MSOX4154A-01

S E R V I C E N O T E

4000 X-Series Scopes

A replacement of the power supply cover is needed when the cabinet assembly is replaced.

New revision cabinet assembly (54709-64401)

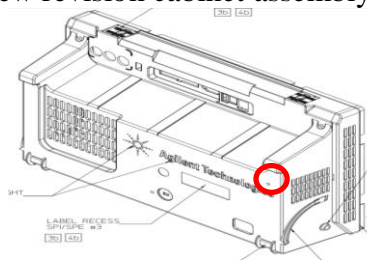
2. If the cabinet assembly is the new revision, proceed with repair as normal
3. If the cabinet assembly is the old revision
 - a. Replace the power supply cover (54695-00103) with new revision
 - b. Replace cabinet assembly as usual (54709-64401)
 - c. Insert screw (0515-0380) into the new screw hole on the cabinet assembly (circled below)
